Access Compliance Report

Public Rights-of-Way

(Curb Ramps)

Intersection ID: 4705	Main Street: HARRIS_HOUSTON_RD	Cross Street: KEMPSFORD_DR	Location: W
ADA ID: 6AD7E6131264	Ramp Type: Perp	Initial Pass/Fail: Fail	Overall Compliance: No
Severity Score: 26.25			
Codes/Mitigation Info/Possible Solution		Field Measurements/Component Compliance

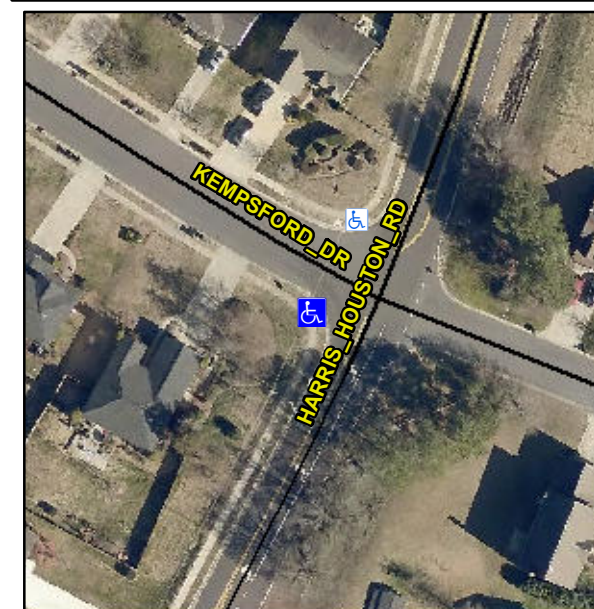
R304.2.2, R304.5.3

Compliance	Description	Data	Compliance	Description	Data
N/A	Ramp Length (in)	46.0	No	Ramp Slope (%)	12.5
Yes	Ramp Width (in)	49.0	No	Ramp XSlope (%)	5.0
N/A	Flare Type LT	N/A	N/A	Flare Type RT	N/A
N/A	Flare Slope LT (%)	N/A	N/A	Flare Slope RT (%)	N/A
N/A	Flare Traversable LT?	N/A	N/A	Flare Traversable RT?	N/A
N/A	Landing Length (in)	N/A	N/A	DWS Provided?	N/A
N/A	Landing Width (in)	N/A	N/A	DWS Contrast?	N/A
N/A	Landing Slope (%)	N/A	N/A	DWS Length (in)	N/A
N/A	Landing X Slope (%)	N/A	N/A	DWS Full Width?	N/A
N/A	Landing Curb? (Y/N)	N/A	N/A	DWS Offset (in)	N/A
N/A	Shared Landing?	N/A			
N/A	Gutter Ponding?	N/A	N/A	Gutter Slope (%)	N/A
N/A	Gutter Lip Ht (in)	N/A	N/A	Gutter X Slope (%)	N/A
N/A	Painted X Walk1?	No	N/A	Painted X Walk2?	N/A
	X Walk 1 Direction	To NE		X Walk 2 Direction	N/A
N/A	X Walk 1 Width (in)	N/A	N/A	X Walk 2 Width (in)	N/A
	X Walk 1 Slope (%)	1.4		X Walk 2 Slope (%)	N/A
	X Walk 1 X Slope (%)	5.2		X Walk 2 X Slope (%)	N/A

Remove & Replace Entire Ramp.
